Preliminary Consultation
MONTGOMERY COUNTY HISTORIC PRESERVATION COMMISSION
STAFF REPORT

Address:	3 Primrose Street, Chevy Chase	Meeting Date:	3/24/2021
Resource:	Contributing Resource Chevy Chase Village Historic District	Report Date:	3/17/2021
Applicant:	William Curtin Outerbridge Horsey, Architect	Public Notice:	3/10/2021
Review:	Preliminary Consultation	Staff:	Dan Bruechert
PROPOSAL:	Building Modifications

3 DORMER OPTION 3

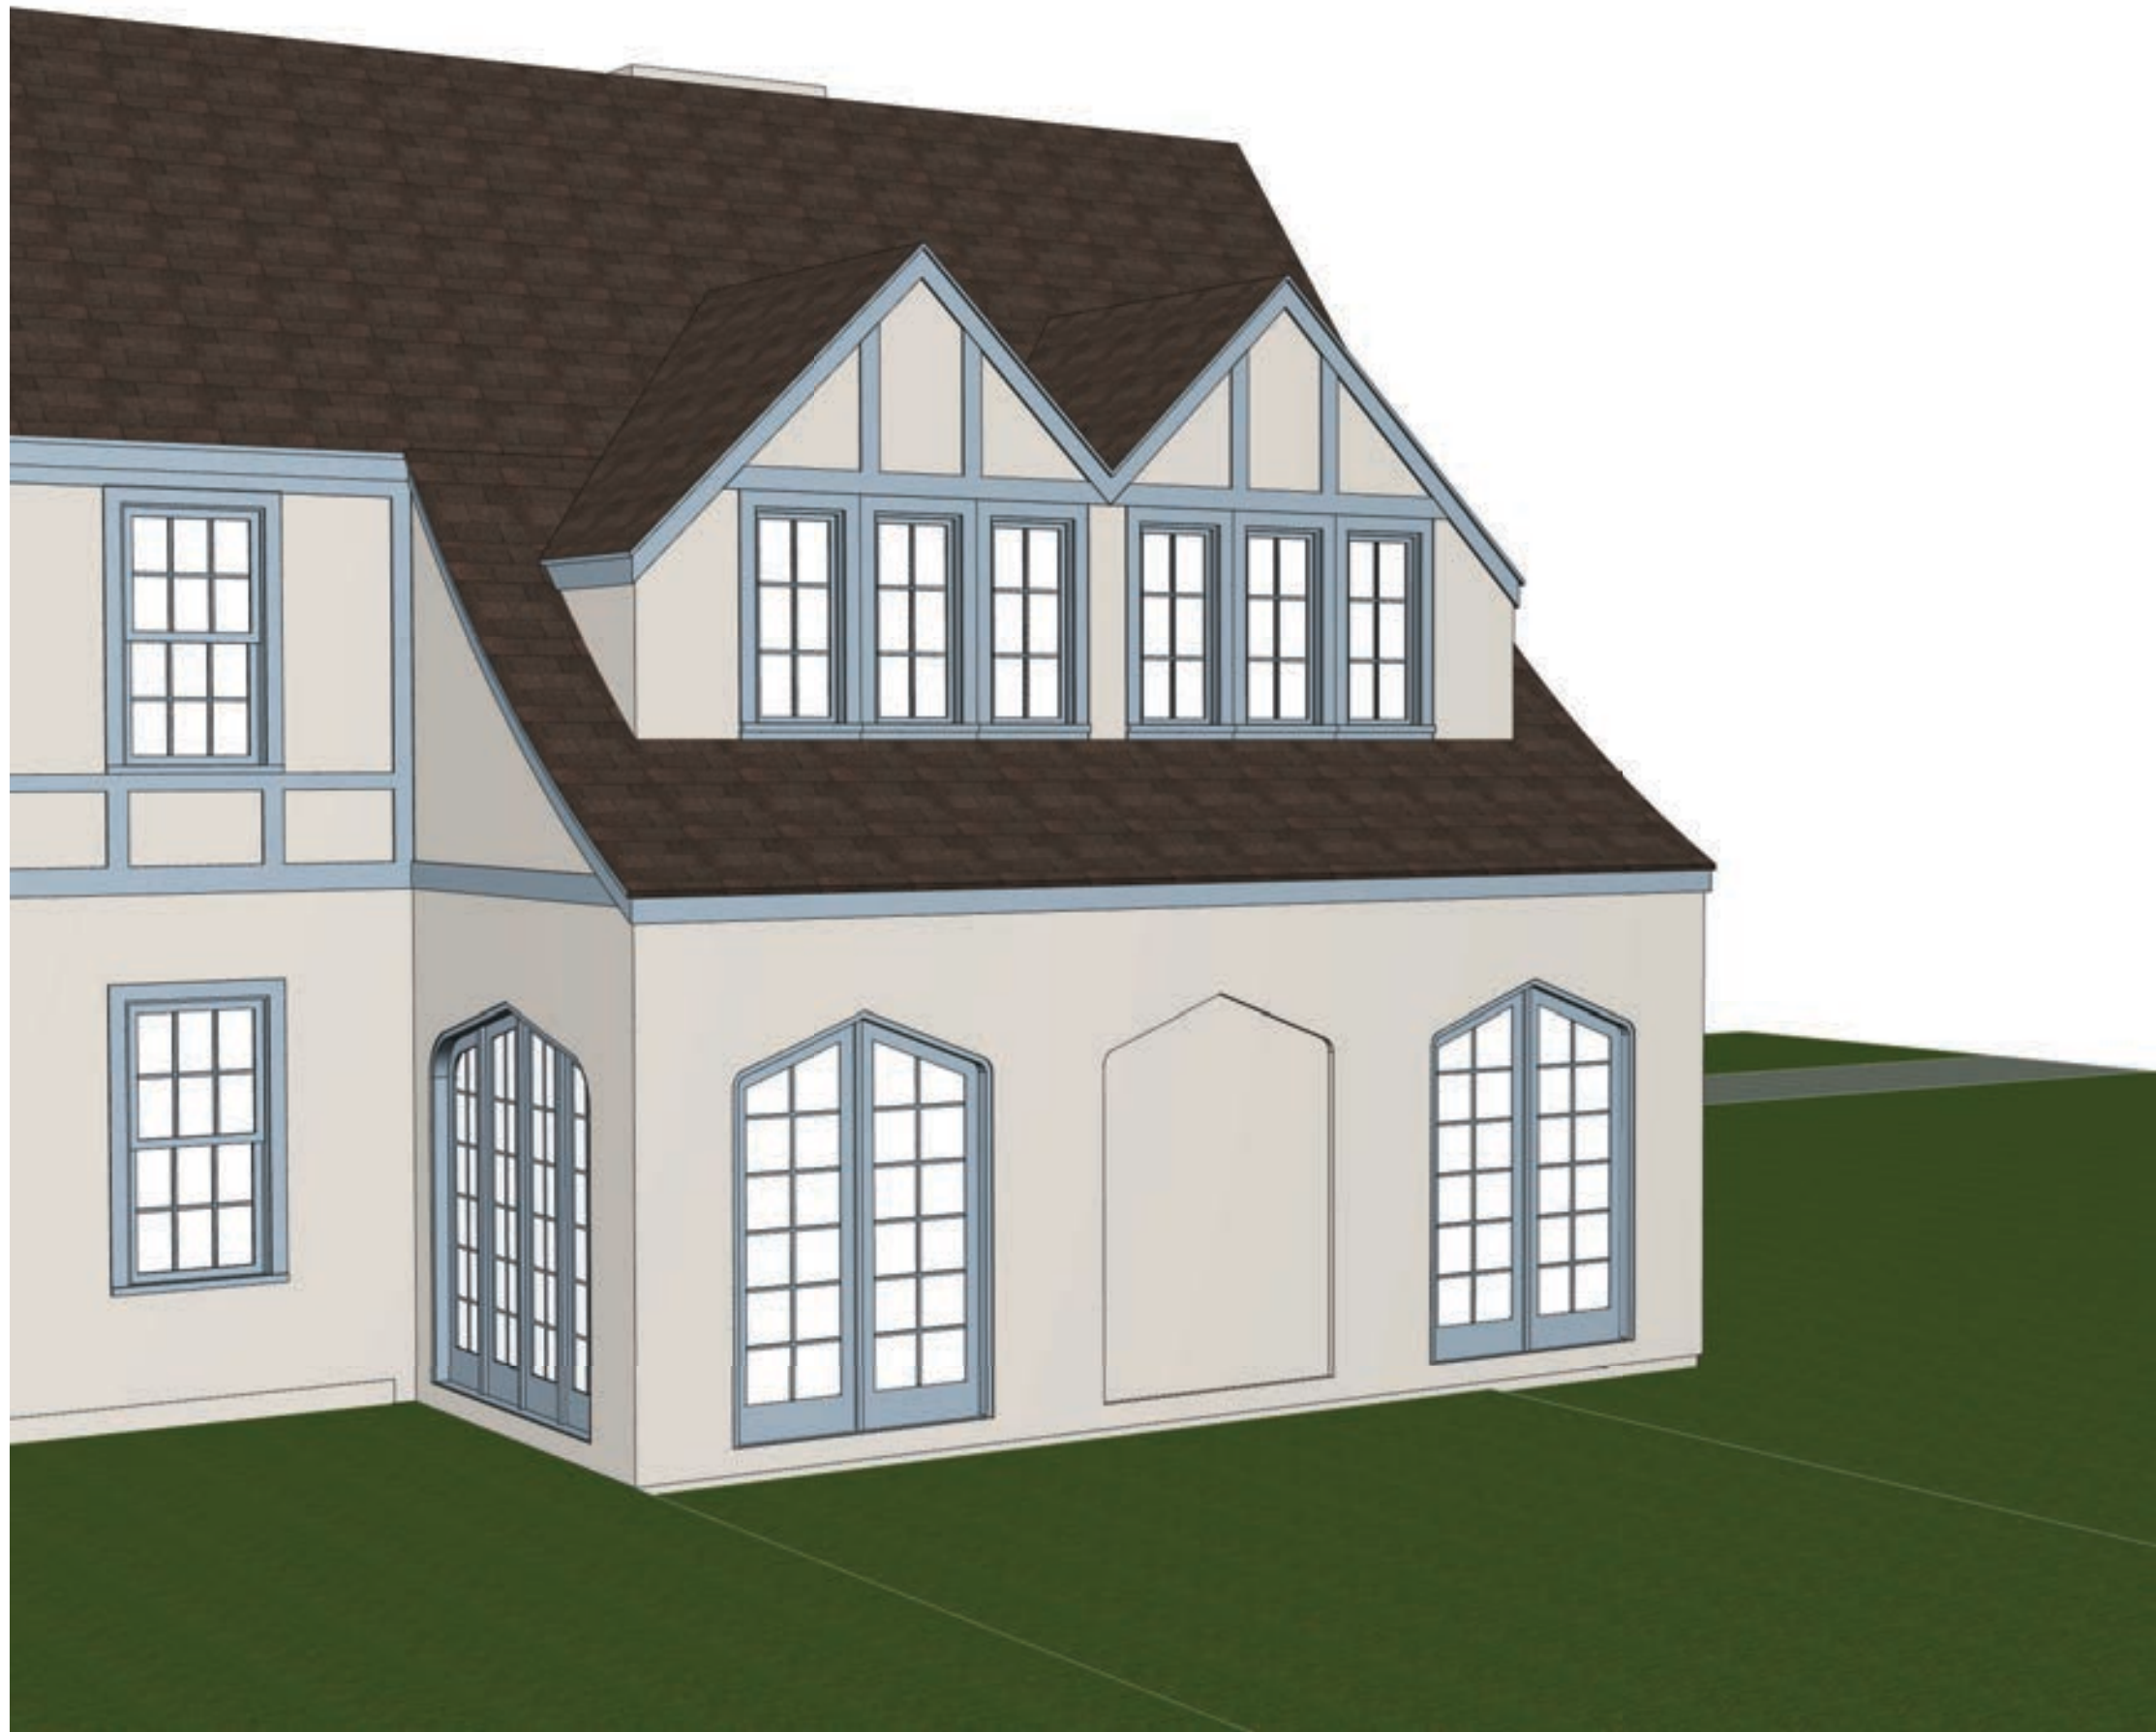
The submitted drawings include three design concepts for the HPC's consideration. All three options would match the stucco walls and slate roof found throughout the house. The Options are as follows:

- Option 1: a single shed dormer;
- Option 2: a pair of smaller gables with a shed roof in the center; and,
- Option 3: a pair of large gables with half-timbering.

Under a moderate scrutiny review, Staff finds that any of the three designs are approvable. Staff strongly supports Option 1 because its simple form will better blend in with the historic house without calling undue attention to a new architectural element that will be very visible from the streetscape. Staff finds Options 2 and 3, while well-designed, create additional roof shapes that could visually distract from the already complex house form.

Staff Recommends the applicant makes revisions based on the HPC's feedback and returns for a HAWP.
